**September 24, 2019**  
**BOARD OF COUNTY COMMISSIONERS**  
**ORANGE COUNTY, FLORIDA**  
**Addendum No. 5, IFB Y20-702-RC**  
**ORANGE COUNTY CONSTRUCTION OF COMMUNITY PARK ON PARCEL J**

**OCIP PARCEL J: CONCESSIONS, OFFICE AND RESTROOM BUILDING**

DOOR SCHEDULE AND DETAILS

A-503

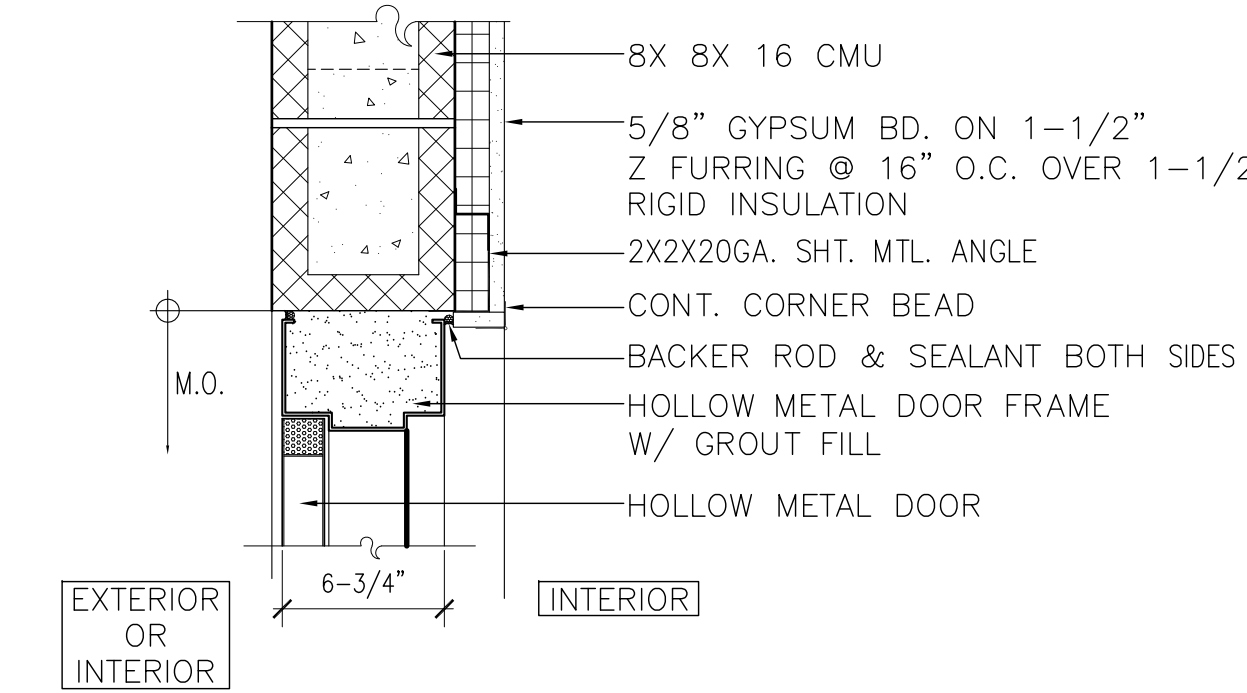
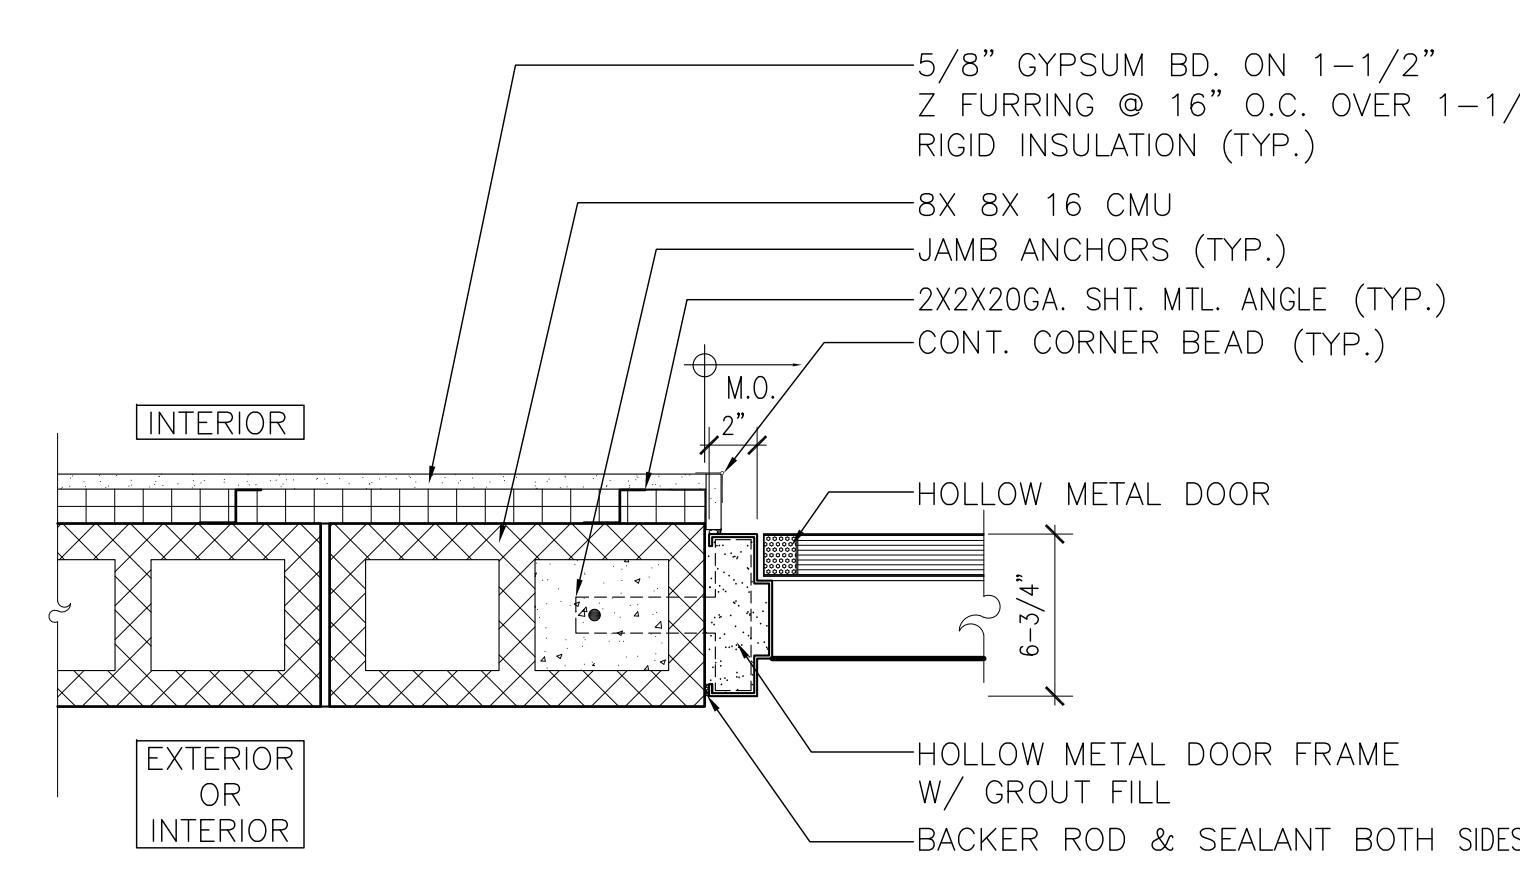
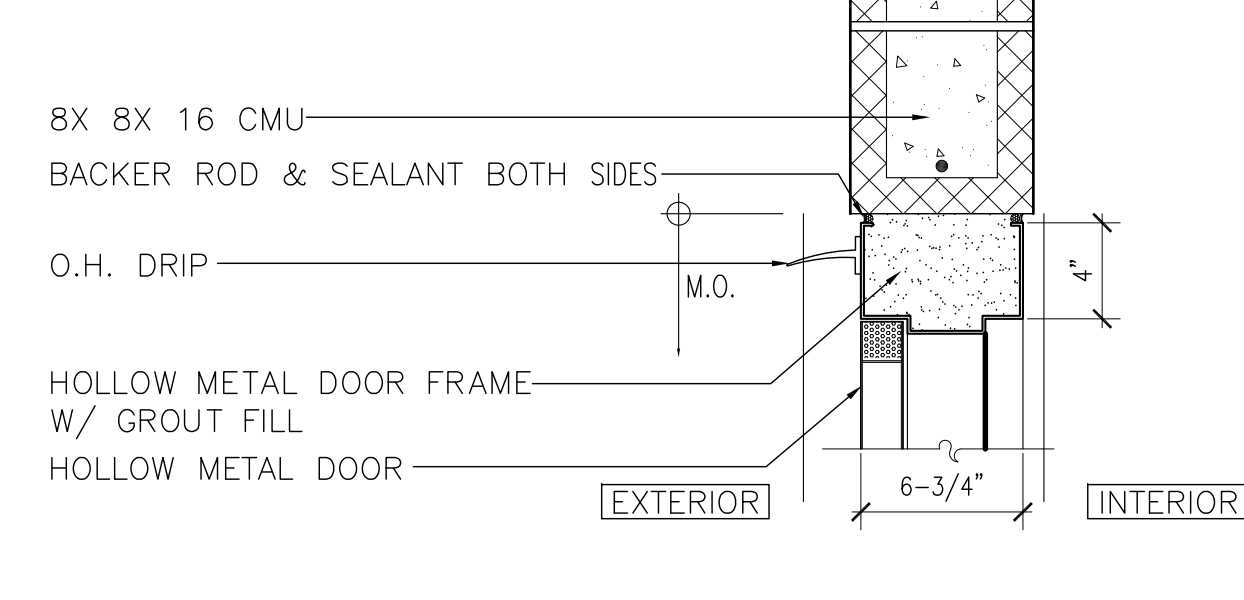
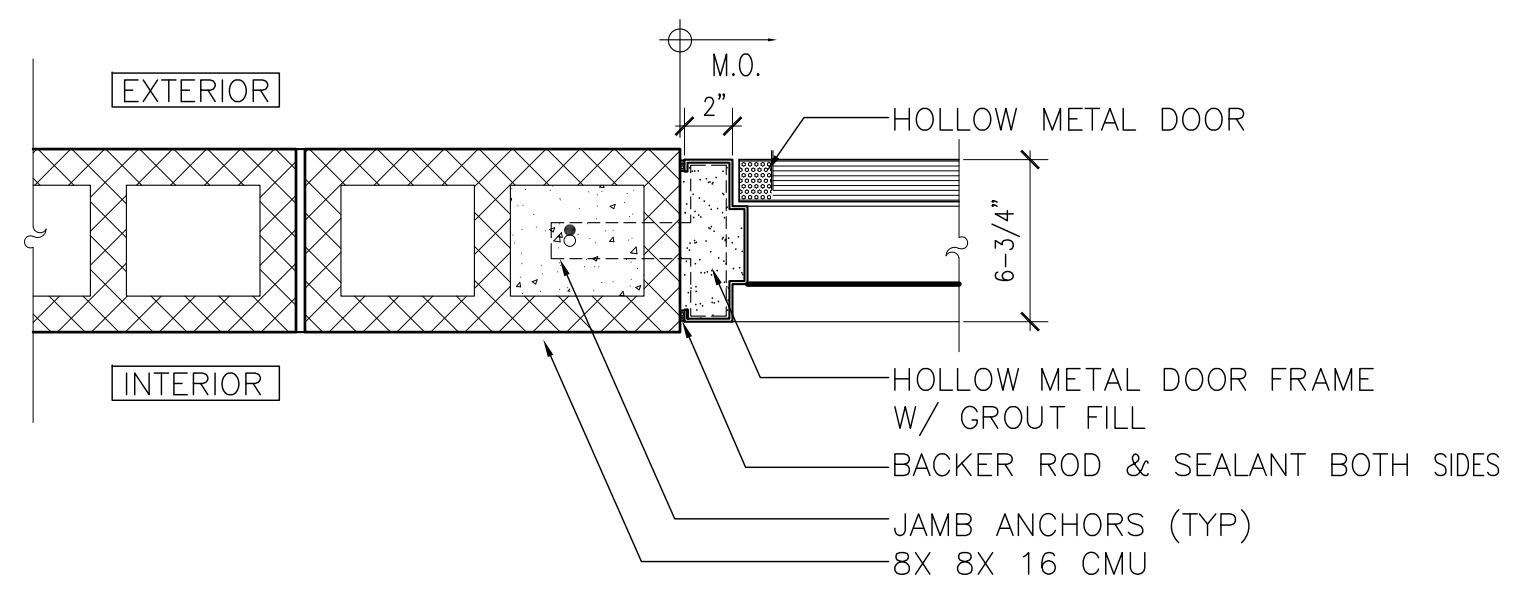
- 1. Revision:** The following drawing has been revised to update the hardware set to match the specifications.
  - A-503: Door Schedule and Details Plan dated 9/20/2019 attached and labelled.
